CAMANO ISLAND STATE PARK LAGOON RECONNECTION

Response to Reviewer Comments

Skagit River System Cooperative

May 1, 2014

Average wild juvenile Chinook density for 2004 (19 sites) and 2005 (6 sites) pairs of accessible pocket estuary and adjacent beach habitat in Whidbey Basin. Pocket estuary habitat was preferred by the fish (from Beamer et al. 2006).

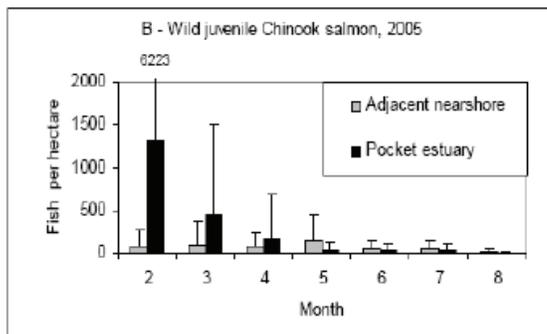
2. *Provide documentation of the utilization of nearshore area at the park by juvenile Chinook.*

As part of the feasibility study mentioned above (McBride and Beamer 2010), potential fish use of the site was assessed using seasonal fish assemblage data from pocket estuary sites that are both geographically nearby and elevationally similar (Elger Bay, Arrowhead Lagoon). Based on these data, it is highly likely that salmon species including juvenile Chinook and chum salmon will utilize the site during late winter and early-mid spring, with Pacific staghorn sculpins, shiner perch, and three-spined sticklebacks dominating the site during the summer months.

Elevationally, the site is analogous to other high-elevation tidal channel salt marshes such as Elger Bay. Species assemblages at high and low elevation marshes are comparable, although surf smelt would not be expected at a high elevation site. Similarly, sticklebacks will likely be more abundant and shiner perch less abundant than at lower elevation marshes. (McBride and Beamer 2010).

Rigorous estimates that include connectivity and other factors have not been used to estimate juvenile Chinook carrying capacity at the site, but based upon the average densities shown above, peak densities could be expected to range from roughly 100 fish/hectare to 1250 fish/hectare. For a project footprint that would encompass 4 acres (1.6 hectare) of the site, this translates to 160 to 2,000 fish.

Shaded relief map of Lowell Point, with relict lagoon and inlet channel outlined. Low elevation areas are shown in blue and purple.

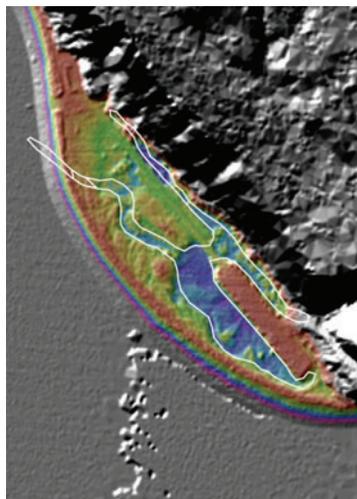
5. *Critical question: Was this site ever a lagoon, or a freshwater wetland? Seems to be too elevated for natural processes. Maybe occasional wash over.*

This topic was originally addressed during preliminary feasibility study (McBride and Beamer 2010). While historic maps do not show a lagoon at the site, it clearly exhibits topographic features and elevations that indicate that a lagoon was once present at the site. Hugh Shipman, a coastal Geologist with the Washington Department of Ecology, agrees with this assertion, as noted in the final CAMP document (State Parks 2013):

“The low area of Lowell Point began as a large wetland and/or lagoon behind a long curving spit. Because it is low-lying, portions are subject to flooding during unusually high tides. This area was very likely a tidal marsh and lagoon prior to development. There appears to have been a tidal inlet at the north end. The details aren’t completely clear, but this is consistent with observations of the current landscape and with similar features around the Sound. This area has been identified by the Skagit River System Cooperative for a potential area for habitat restoration project to help in the recovery of wild Skagit Chinook salmon populations.”
